**ADDENDUM NO. 5****BID NO. 24-03**

To all holders of the specifications, the following corrections are hereby made. All other items shall remain unchanged. This addendum shall become part of the Contract Documents for the above referenced project.

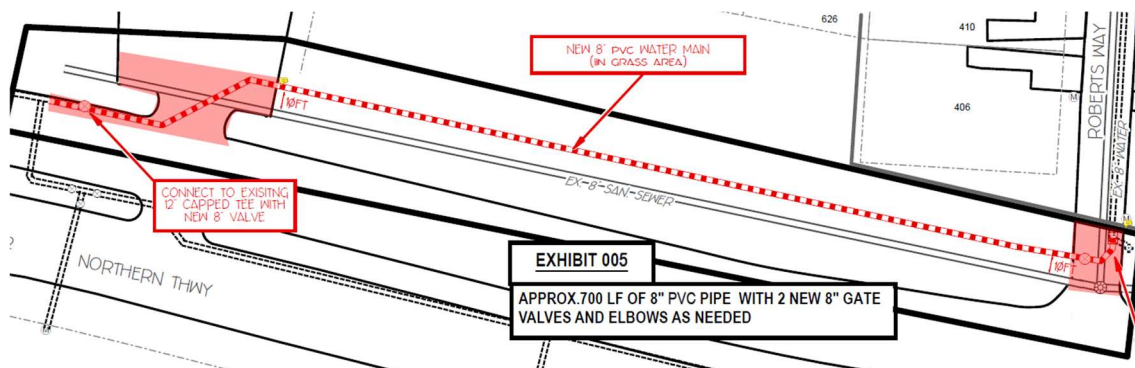
Q5) Exhibit 5 quantity of Pavement Restoration seems high based on the proposed limits of disturbance. Please clarify what areas make up the 800 SY of Mill & Overlay.

**A5) The 800 SY of Mill & Overlay estimated for this exhibit is based on approximately 7200 sqft that could potentially be disturbed in the areas shown below.**
